# Access Compliance Report

## Public Rights-of-Way

### (Curb Ramps)

Intersection ID: 5538	Main Street: GOLDEN_HEIGHTS_CT	Cross Street: NORTHWOODS_FOREST_DR	Location: NE
ADA ID: 79FD46CD3942	Ramp Type: Perp	Initial Pass/Fail: Fail	Overall Compliance: No
Severity Score: 1.25			
Codes/Mitigation Info/Possible Solution		Field Measurements/Component Compliance

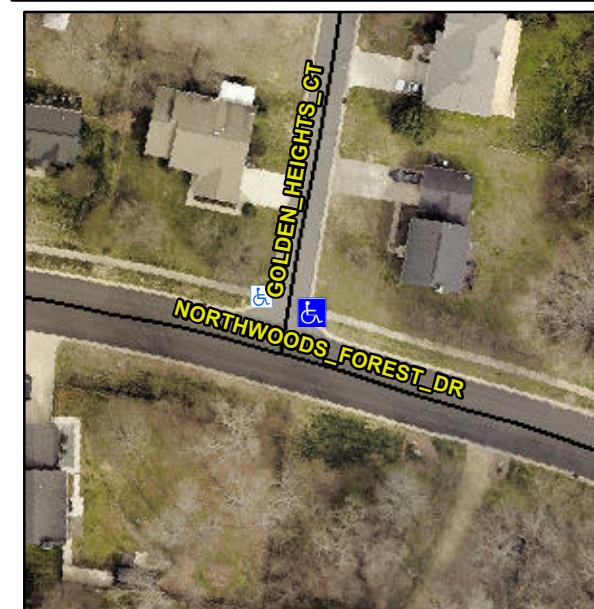
**R304.5.3**

Compliance	Description	Data	Compliance	Description	Data
N/A	Ramp Length (in)	28.0	Yes	Ramp Slope (%)	6.4
Yes	Ramp Width (in)	48.0	No	Ramp XSlope (%)	3.5
N/A	Flare Type LT	N/A	N/A	Flare Type RT	N/A
N/A	Flare Slope LT (%)	N/A	N/A	Flare Slope RT (%)	N/A
N/A	Flare Traversable LT?	N/A	N/A	Flare Traversable RT?	N/A
N/A	Landing Length (in)	N/A	N/A	DWS Provided?	N/A
N/A	Landing Width (in)	N/A	N/A	DWS Contrast?	N/A
N/A	Landing Slope (%)	N/A	N/A	DWS Length (in)	N/A
N/A	Landing X Slope (%)	N/A	N/A	DWS Full Width?	N/A
N/A	Landing Curb? (Y/N)	N/A	N/A	DWS Offset (in)	N/A
N/A	Shared Landing?	N/A			
N/A	Gutter Ponding?	N/A	N/A	Gutter Slope (%)	N/A
N/A	Gutter Lip Ht (in)	N/A	N/A	Gutter X Slope (%)	N/A
N/A	Painted X Walk1?	No	N/A	Painted X Walk2?	N/A
	X Walk 1 Direction	To NW		X Walk 2 Direction	N/A
N/A	X Walk 1 Width (in)	N/A	N/A	X Walk 2 Width (in)	N/A
	X Walk 1 Slope (%)	7.6		X Walk 2 Slope (%)	N/A
	X Walk 1 X Slope (%)	0.1		X Walk 2 X Slope (%)	N/A

**Remove & Replace Entire Ramp.**
